**BCC DS**  
**RECEIVED**  
08-MAY-2026  
**APPLICATION REF**  
A007020190

DA Set - 21.02.2024.

DA Set - 15.02.2026.

DA Set - 21.02.2024.  
DA Set - 15.02.2026.

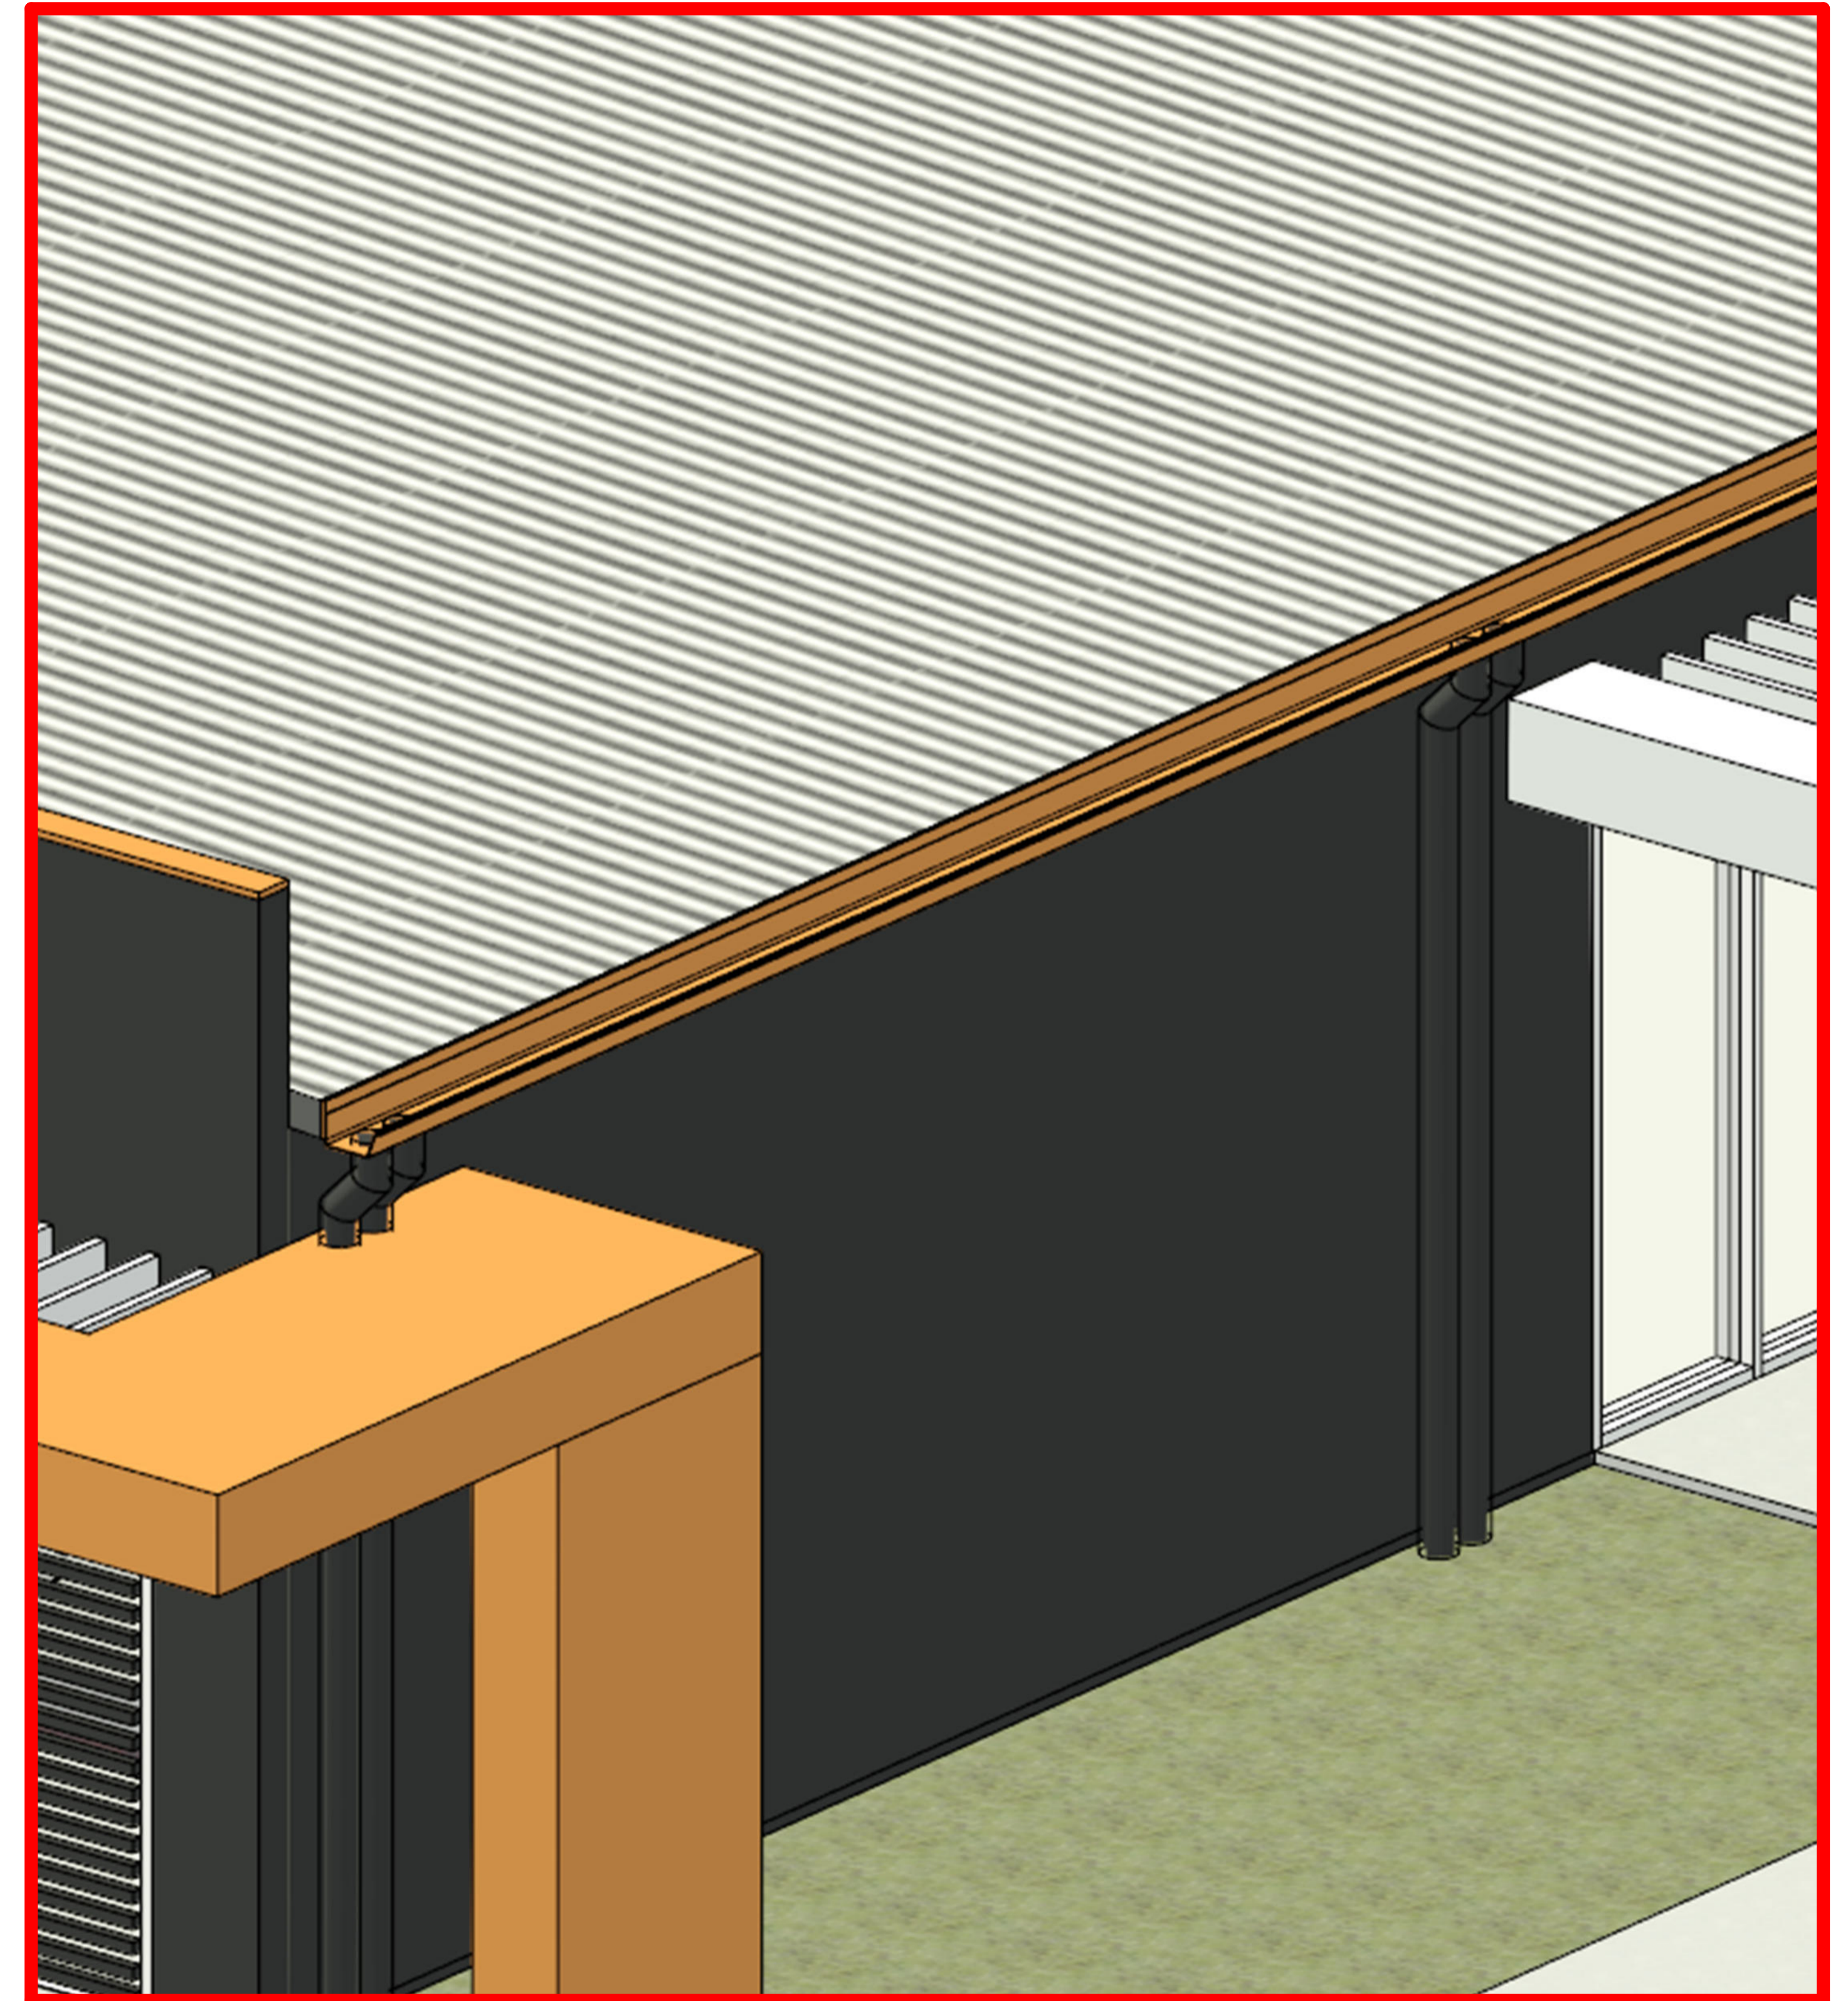
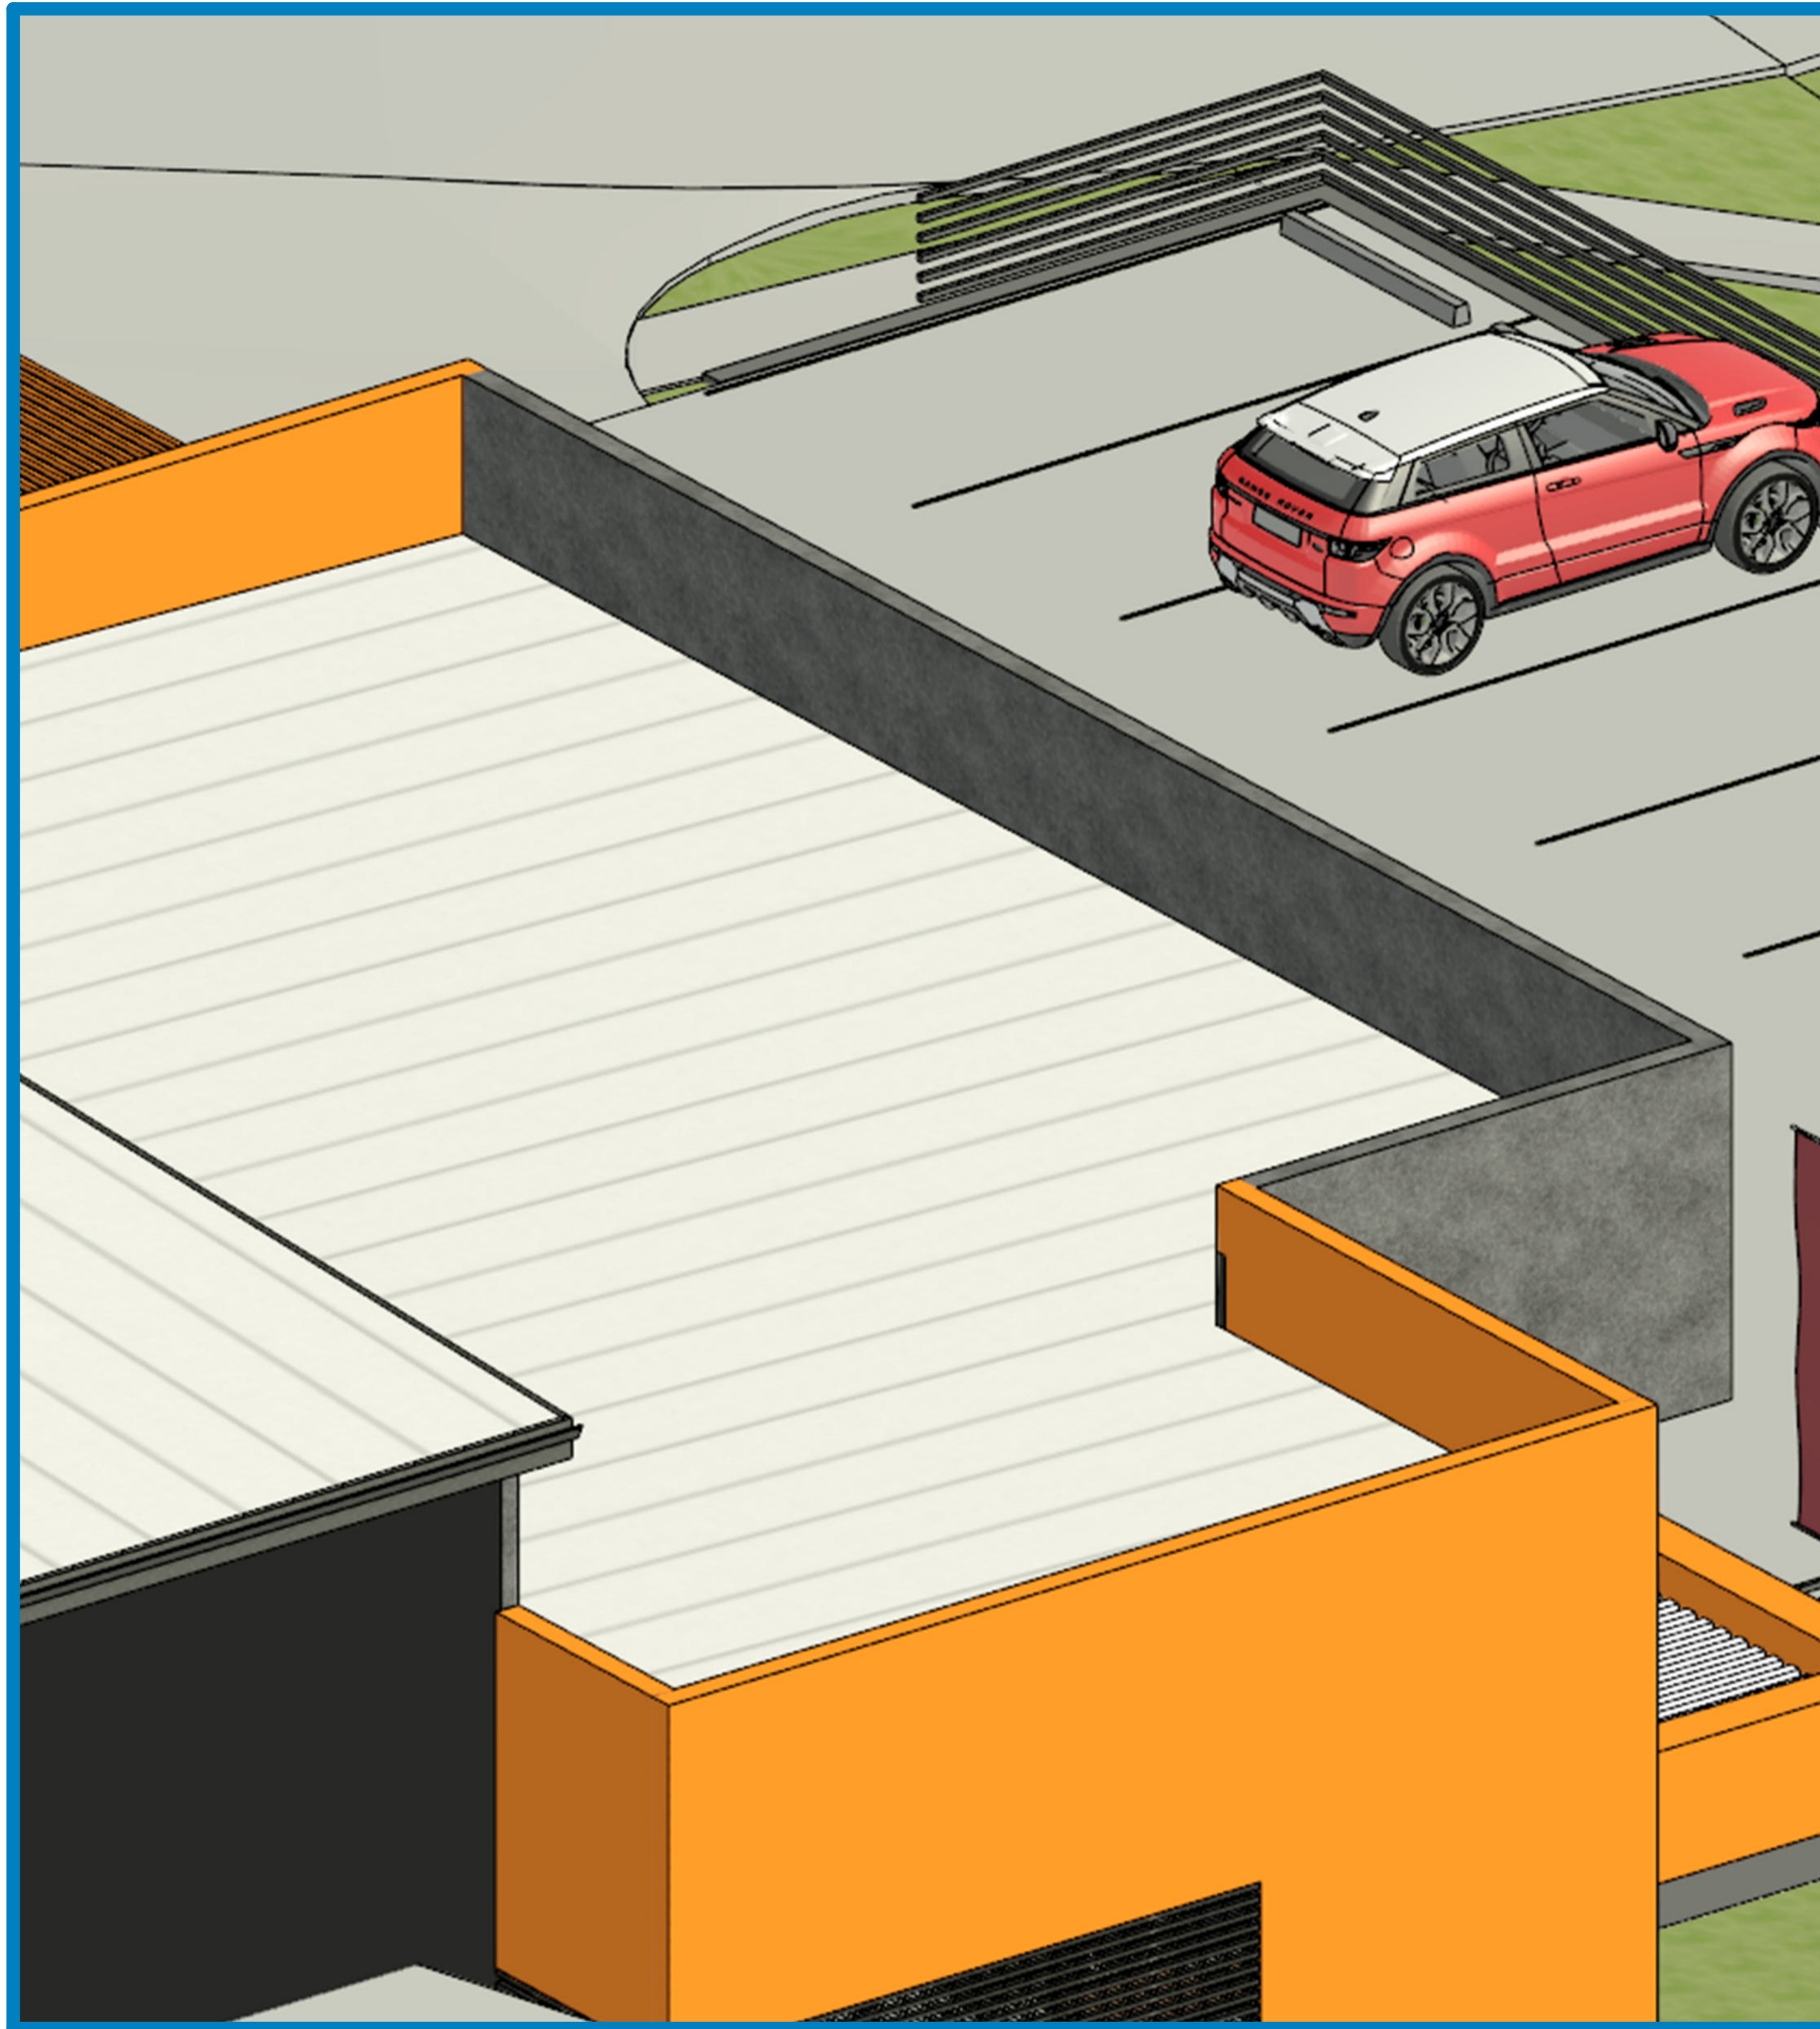
04. The office roof drainage via a "box gutter" has been removed; the roof now discharges at two locations along the front facade via standard gutters and downpipes.
